<b>Docket Number:</b>	16-AFC-01C
<b>Project Title:</b>	Stanton Energy Reliability Center - Compliance
<b>TN #:</b>	229730
<b>Document Title:</b>	Petition To Amend
<b>Description:</b>	SERC PTA - Site Delineation
<b>Filer:</b>	Susan Fleming
<b>Organization:</b>	Stanton Energy Reliability Center, LLC
<b>Submitter Role:</b>	Applicant
<b>Submission Date:</b>	9/13/2019 8:56:51 AM
<b>Docketed Date:</b>	9/13/2019

# PETITION TO AMEND

STANTON ENERGY RELIABILITY CENTER  
(16-AFC-01C)

SITE DELINEATION

**PROJECT DESCRIPTION - FIGURE 4B**  
 Stanton Energy Reliability Center - General Arrangement for Parcel 2

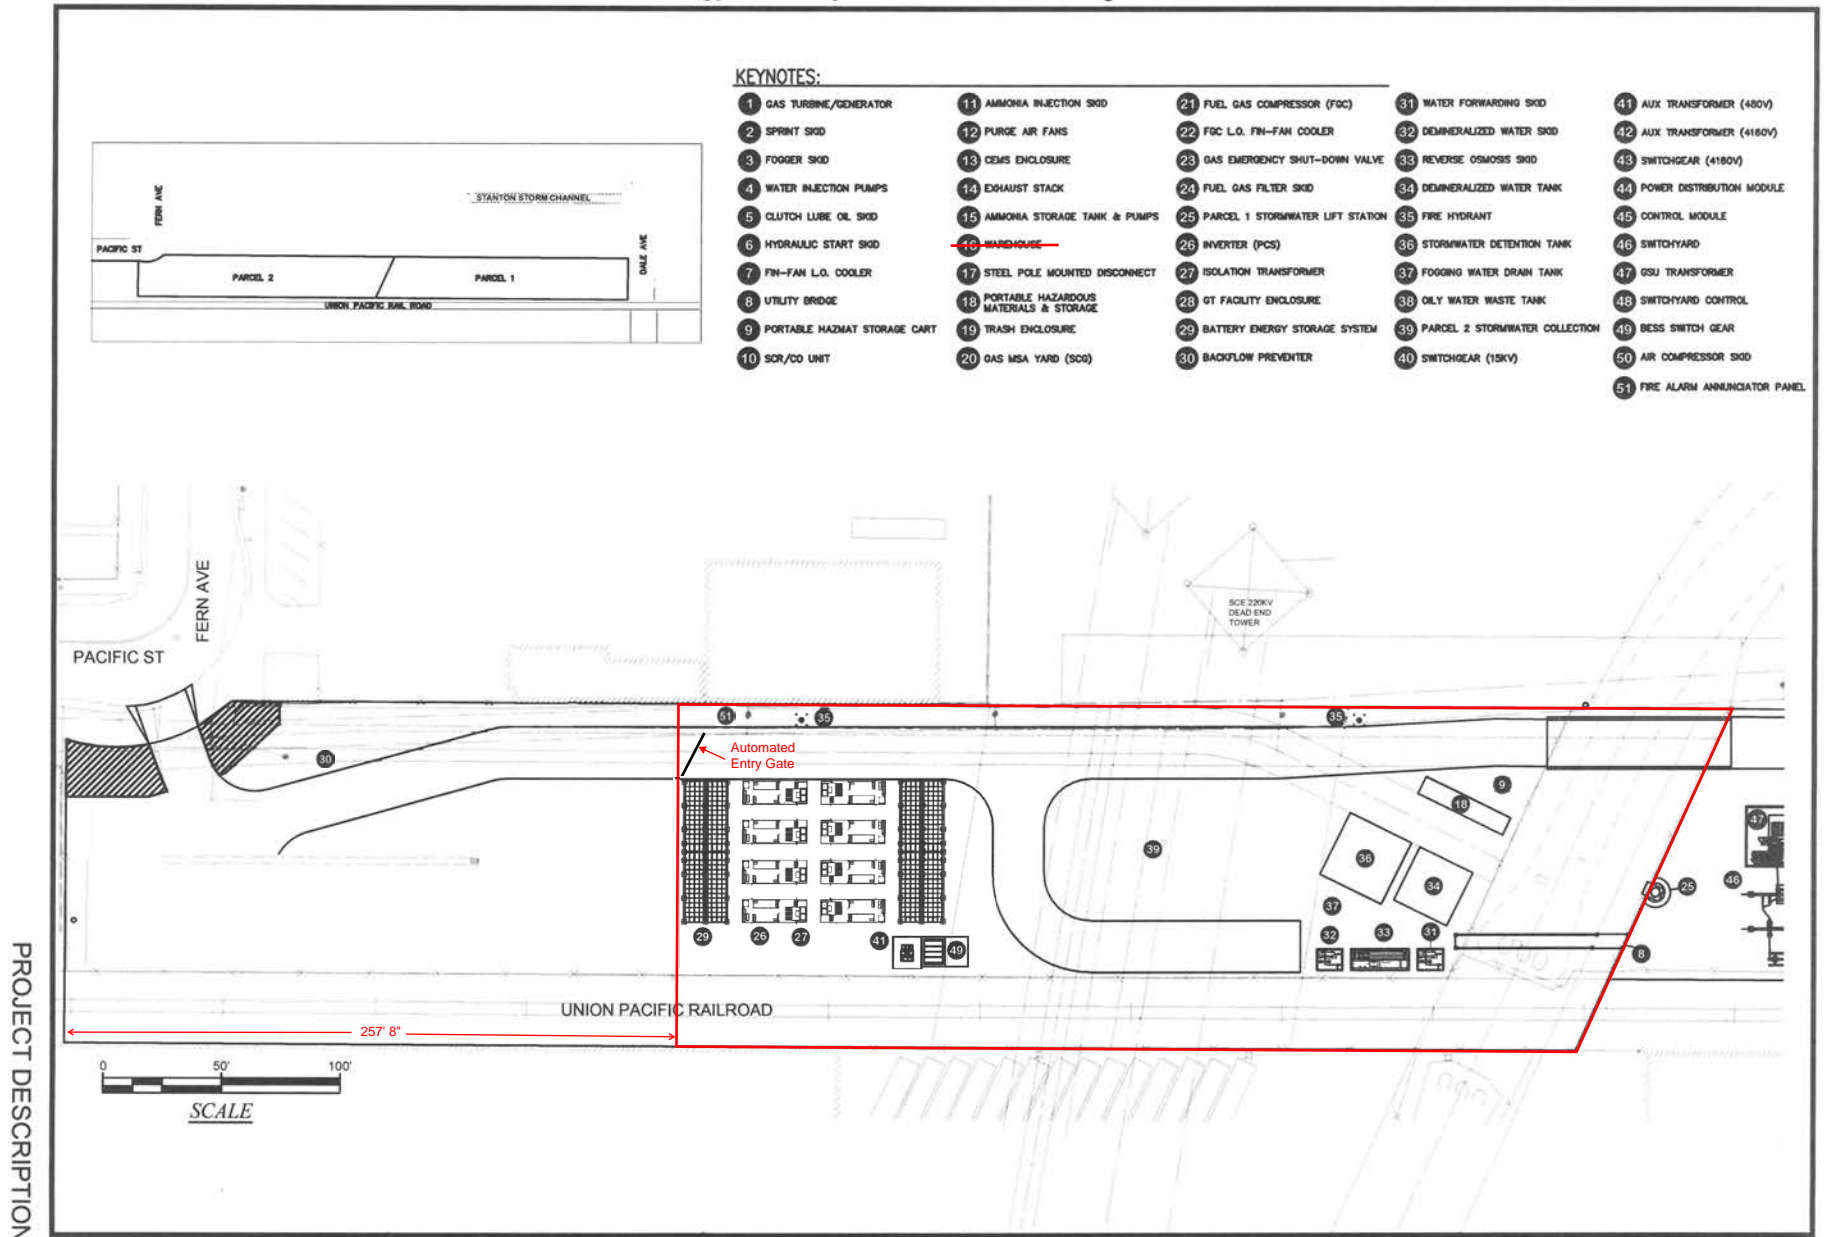
SERC consists of two parcels. Parcel 1 extends from the frontage on Dale Avenue west to the existing Stanton Storm Channel. Parcel 2 extends from the Stanton Storm Channel east to Pacific Street. This Petition does not affect Parcel 1, and only modifies the westernmost boundary of Parcel 2. Specifically, SERC, LLC proposes to modify the western boundary of the site as shown on Figure Revised 4B attached, essentially relocating the site boundary approximately 258 feet to the east of the current boundary at Pacific Street.

SERC, LLC also requests elimination of the Warehouse, which was to be located on the westernmost portion of Parcel 2.

To ensure the SERC facility complies with the existing Conditions of Certification, SERC, LLC would construct a security fence along the new proposed westernmost boundary with a gate to maintain the secondary access from Pacific Street. SERC, LLC will be modifying its security plan to reflect these changes.

| 6 HYDRAULIC START SKID         | <del>16 WAREHOUSE</del>                   | 26 INVERTER (PCS)                   | 36 STORMWATER DETENTION TANK      | 46 SWITCHYARD                   |
